290
GOVERNMENT ACCOUNTABILITY PROJECT

Re: Diablo Canyon Nuclear Power Plant, Units 1 and 2
Docket Numbers 50-275 and 50-323 (2206)

This statement is given freely and without inducement by Charles C. Stokes in response to the PG&E presentation to the NRC on July 2, 1984 in Bethesda, Maryland, on the seven licensing conditions resulting from Mr. Isa Yin's inspection of my allegations and other issues. This affidavit also challenged the NRC staff's willingness to license the Diablo Canyon plant despite significant, unresolved questions material to the license. Through tactics including delay of compliance for some 6,000 licensing commitments; delay in investigating my allegations of document destruction; failure to provide necessary data to verify or rebut Pacific Gas and Electric's (PG&E) asserted conclusions; and obstruction of Mr. Yin's work, the staff has guaranteed that we will not adequately know whether Diablo Canyon is safe if the Commission votes July 30 on a commercial license. This is intolerable, since I have learned of still more false or misleading information in PG&E's previous denials to the NRC of any significant problems at the plant.

Figure 1

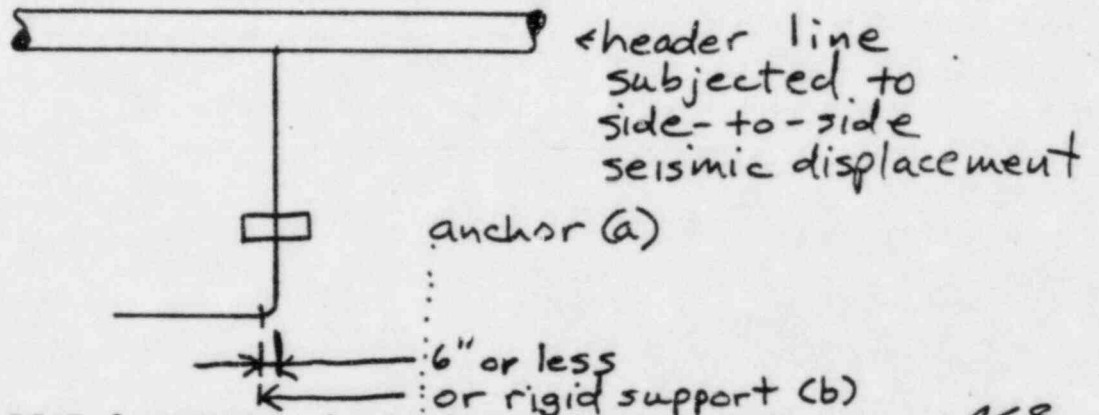
(1) A branch line being subjected to axial buckling, or tensile stress.

From the NRC and PG&E documents, it is impossible to tell if NRC or PG&E looked at this potential problem.

Figure 2

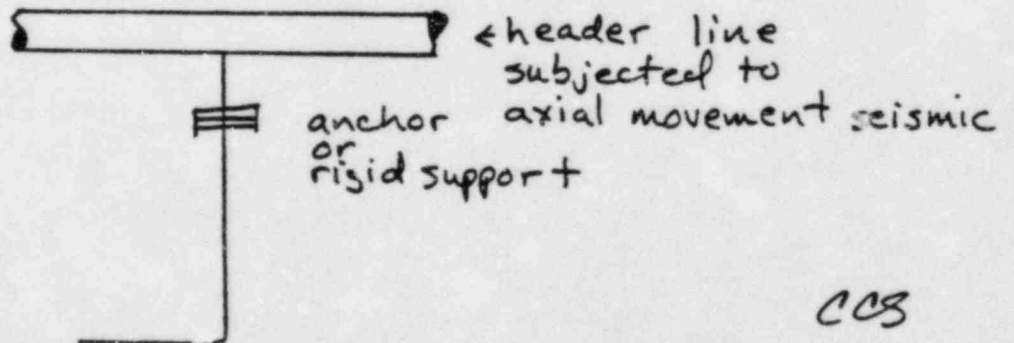
(2)

Figure 3

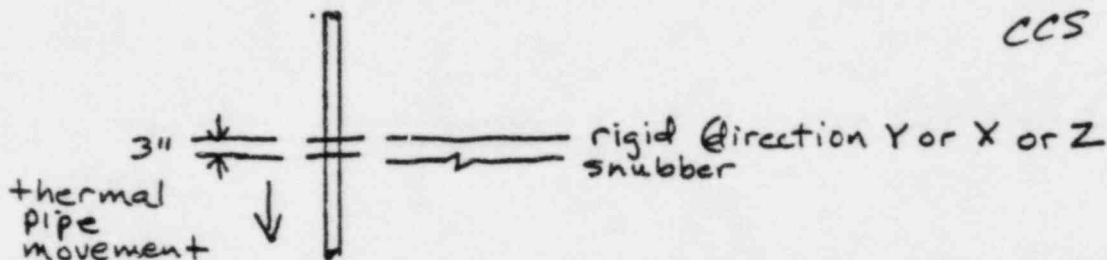
This pair of supports are usually shown on the stress isometric drawings as being at the same location. It is a special case where the pipe must be seismically restrained but allowed to move for thermal reasons. It is possible by using the six-inch construction tolerance to place the snubber (see above) on the opposite side of the rigid restraint. As a result, when the pipe moves, the snubber clamp binds on the rigid restraint, either causing the restraint to fail or the pipe to overstress. This is also applicable to a spring-can and a rigid restraint in the lateral direction.

Figure 4

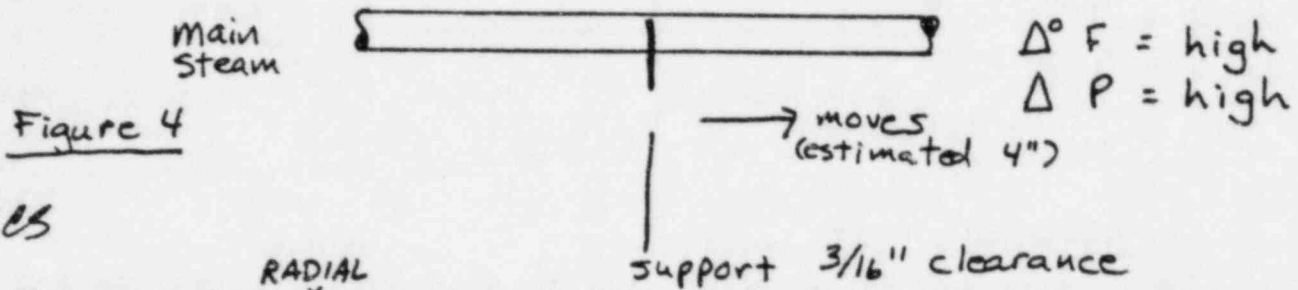
The approximate expansion of this line can be one inch. This line will grow in length and diameter roughly at the same uniform rate. It will therefore lock up at approximately only one inch of the axial growth. It still has three inches more to go. I estimated four inches movement as a conservative assumption in Figure 4, because at the meeting on Friday Mr. Shipley admitted movements of six inches in some lines. Two possibilities are likely. -- (1) the pipe stronger than the support - support fails, (2) support stronger than pipe - pipe fails.
